Inspection report and landslide reinstatement sign off

Project No.	P.23.1016	Date	25 September 2023
Project Name	Collins Cap Quarry Landslip		
Inspected	28/07/2023	Inspected By	FG
Client	Alltas Engineering		pitt&sherry

Figure 1 - recommended remediation works

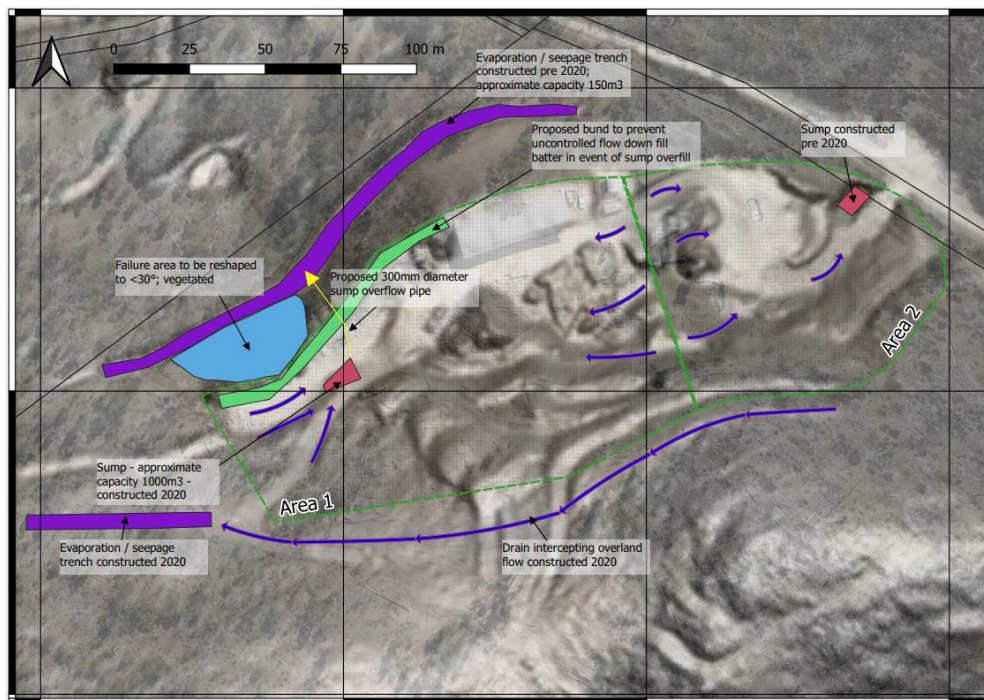
The following remediation works were proposed:

- Reinstatement, reshape and revegetate the failed slope (< 30° angle, compacted to optimum moisture and maximum density)
- Reinstatement northern evaporation ditch
- Installation of overflow pipe; and
- Bund construction.
